# Planning Commission Agenda Item

Date: December 13,  
2023

**SUBJECT: ZN-14-2023 LAKE MEAD & ENGLESTAD MICROBUSINESS (Public Hearing).** Applicant: Clark County Real Property Management. Request: A Property Reclassification of 4.92 acres from C-1 (Neighborhood Commercial District) to MUD-N (Mixed-Use Neighborhood District). Location: 300 feet West of the Intersection of Lake Mead Boulevard and Englestad Street. (APN 139-22-201-005). Ward 2. (For Possible Action)

**RETAIL BUILDING - ELEVATION C**

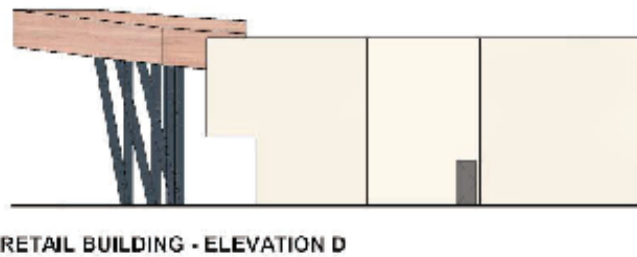
Architecturally, the applicant submitted elevations containing four-sided architecture for the retail building. Elevations A and B appear to be in compliance with the Building Form requirements outlined in the Mixed-Use Design Guidelines. However, Elevations C and D lacks visual interest and have little building articulation or architectural embellishments. All sides of a building shall be coherently designed and treated. A consistent level of detailing and finish is required for all sides of a building. For visual interest, all mixed-use buildings shall incorporate patterns, changes in color, materials, and/or relief such as beltlines, pilasters, pop outs, etc. Appropriately scaled accent features should be used to add visual interest and diversity to building façades. Additionally, the perceived height and bulk of buildings should be relieved by variations in massing and/or articulation of façades to reduce the visual length of long walls. The required changes are relatively minor and will be addressed with the Final Development Plan.
